PROJECT: TTU TRACK AND FIELD
SBC# 364/011-05-2025
BAA Project Number 25007
Cookeville, Putnam County, Tennessee

SUBJECT: Addendum No 1

1 SITE PLAN
ELECTRICAL - DEMO SITE PLAN

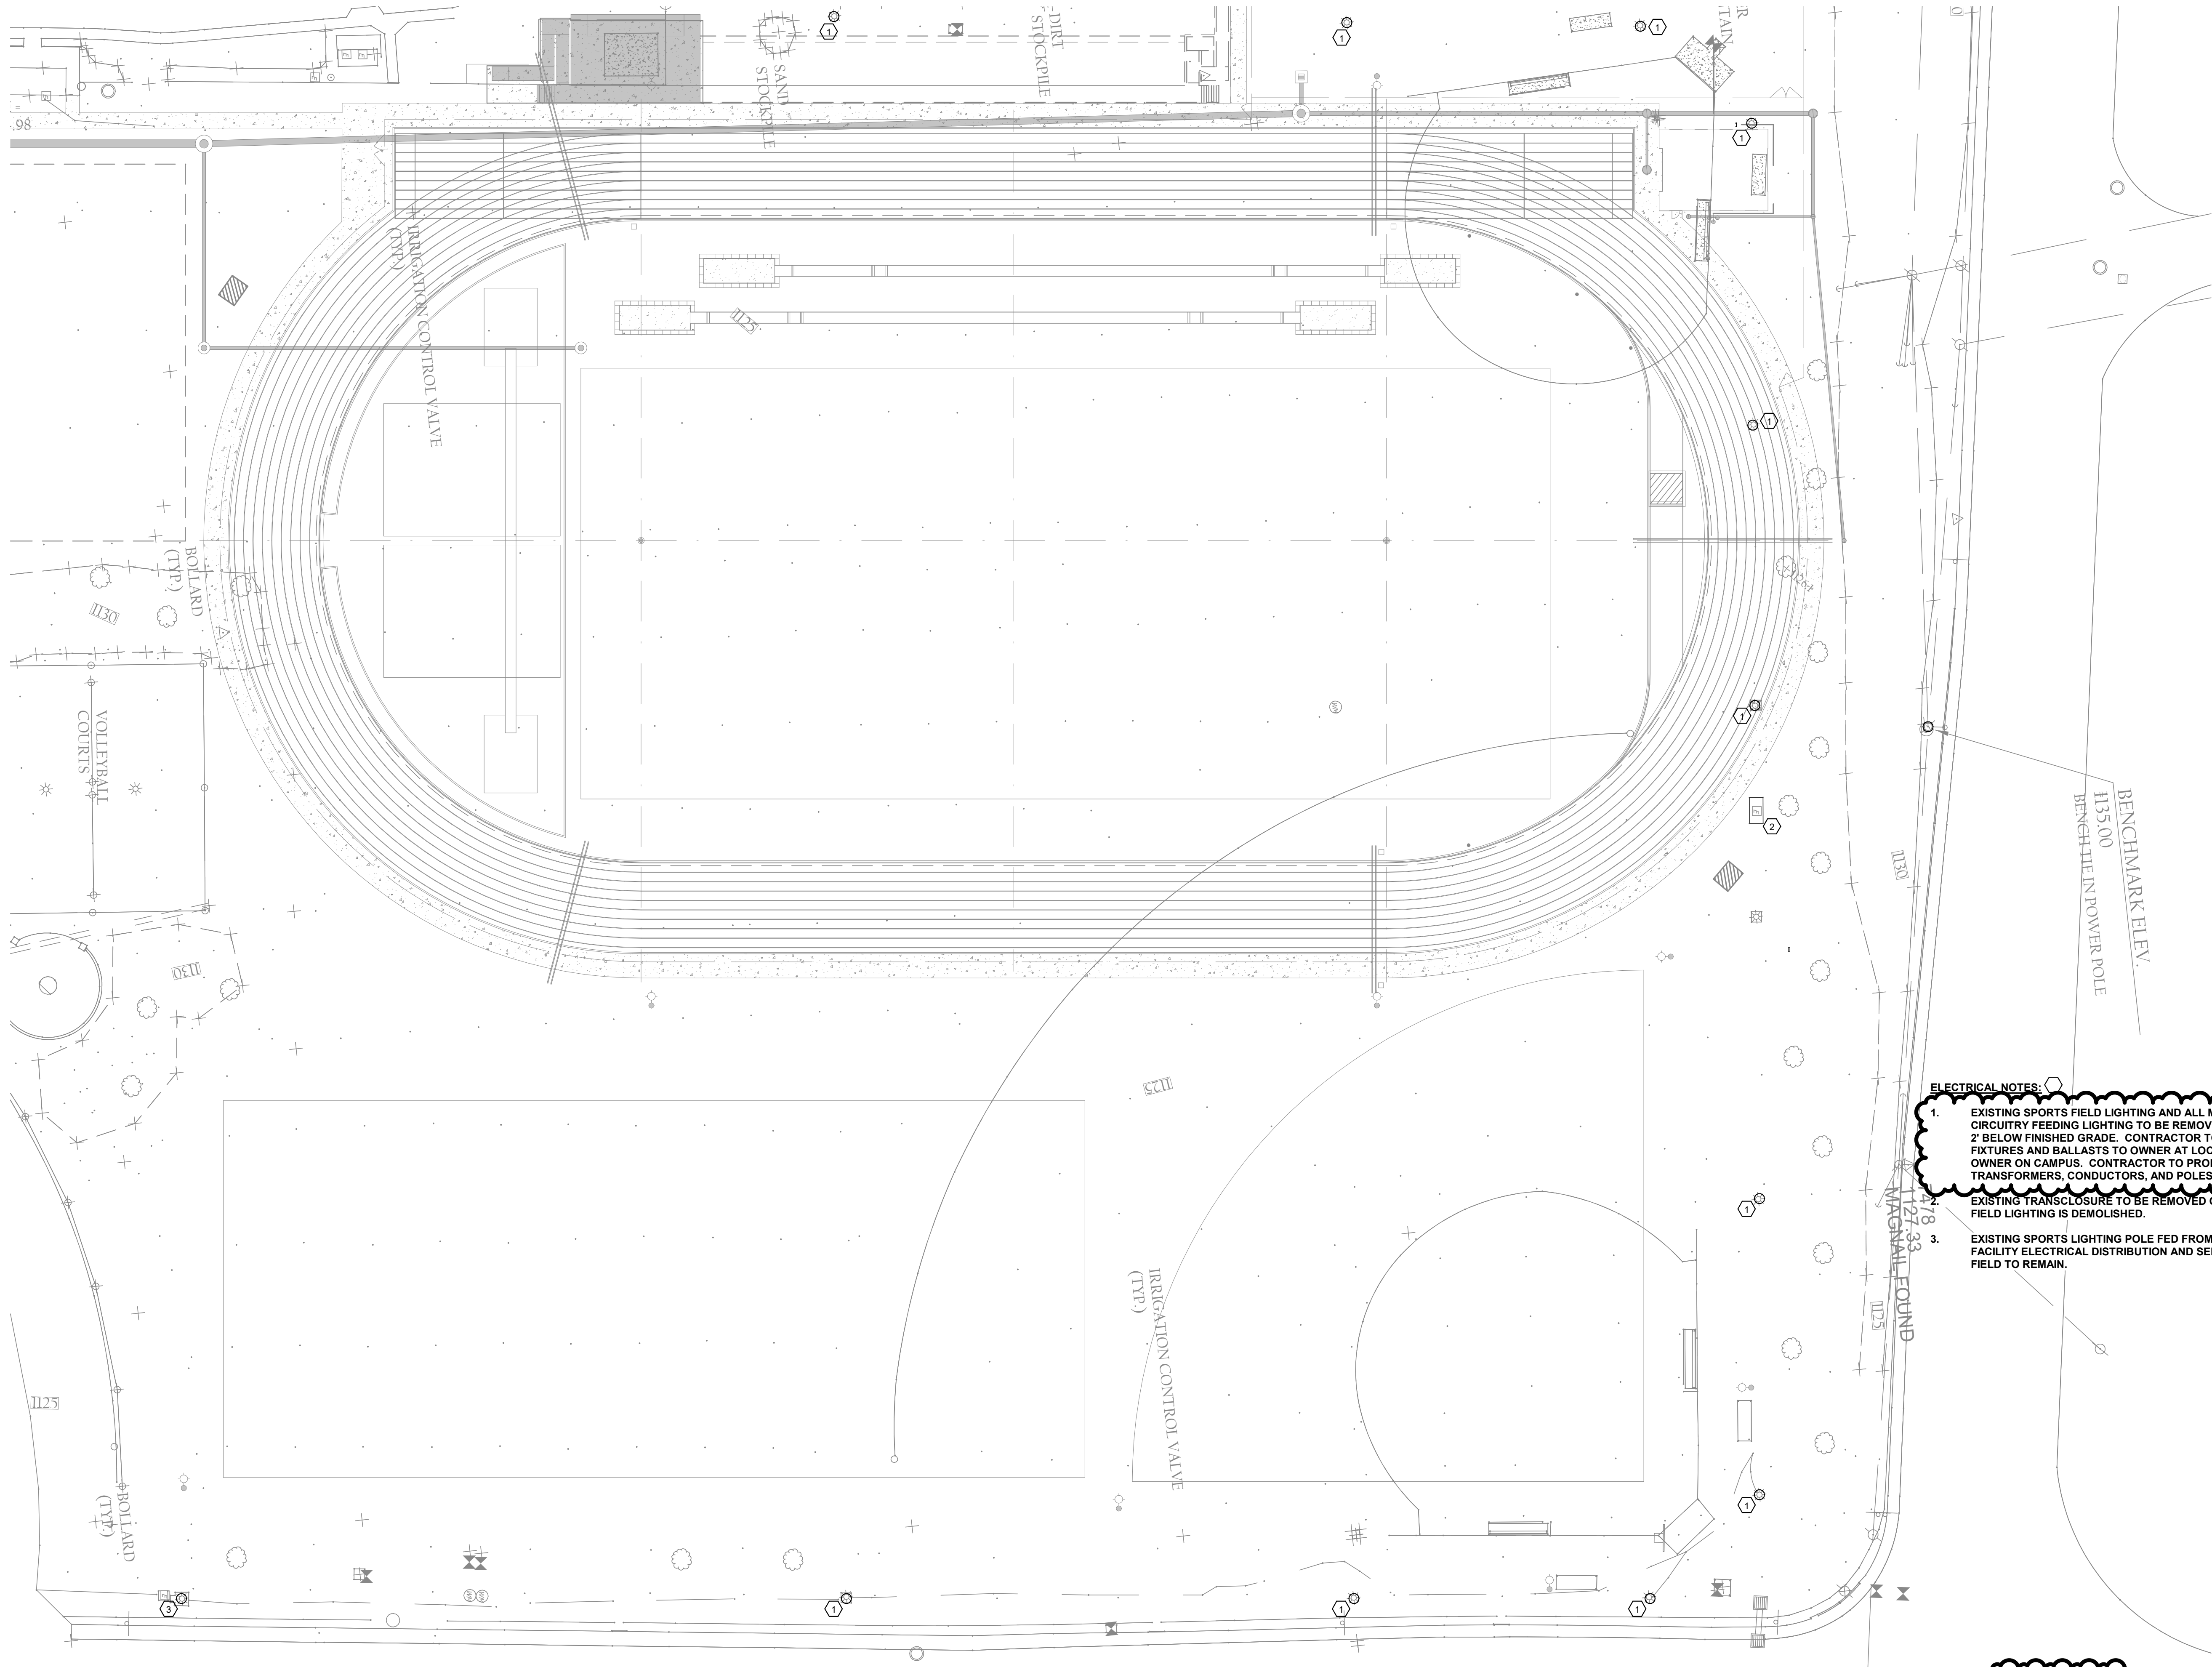
89. Question: What work is required regarding the existing sports lighting poles shown on ED0.01?

Answer: Further clarification has been added to ED0.01.
